Office Action Summary	Application No. 10/775,353	Applicant(s) FREDERICK ET AL.
	Examiner JAMES L. SWIGER	Art Unit 3775

DETAILED ACTION

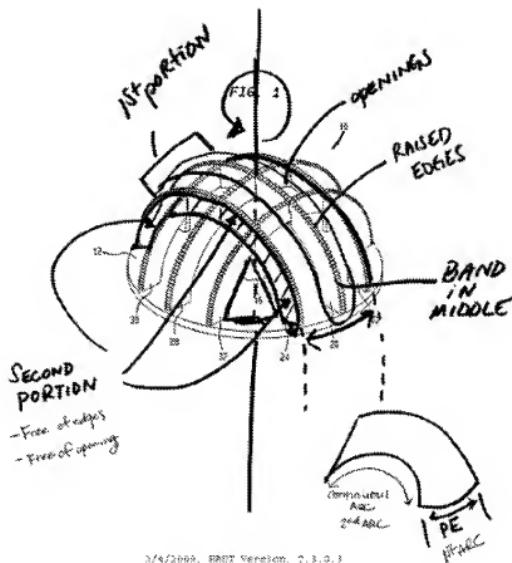
Claims 1, 3-5, 8, 25-26, 27-28, 35 and 37-38 rejected under 35 U.S.C. 112, second paragraph, as being indefinite for failing to particularly point out and distinctly claim the subject matter which applicant regards as the invention. Applicant has not defined what is meant by a peripheral edge forming at least a portion of a first arc. For

examination purposes, the peripheral edge will be interpreted as noted below in the annotated drawing (PE).

The first portion further includes a peripheral edge, "PE," (shown as the bottom edge of the first surface, see annotated drawing and additional drawing in bottom right corner), that forms at least a portion of an arc (it is curved, following the shape of the domed surface), and wherein the first portion intersects with the at least one second portion (it is noted that there is also a second portion on the other side with identical limitations), and wherein this second portion forms a second arc. This second arc extends continuously from where it meets the first arc formed by the PE, over to another point on the PE. See also additional drawing for reference.

The at least one second portion is considered substantially parallel to a rotational axis, and also the two portions (facing one another) are considered parallel to one another. The raised edges as shown in the annotated drawing, may be considered to be confined to a band that straddles the middle portion of the generally dome-shaped surface. The raised edges that cross the longer band as noted, are part of a center area where they are confined. In terms of the first portion being less than half of the dome shaped surface, it appears that factoring the total cutting area yielded by the reamer, this first portion would be less than half of the total area of the exterior surface of the hollow body.
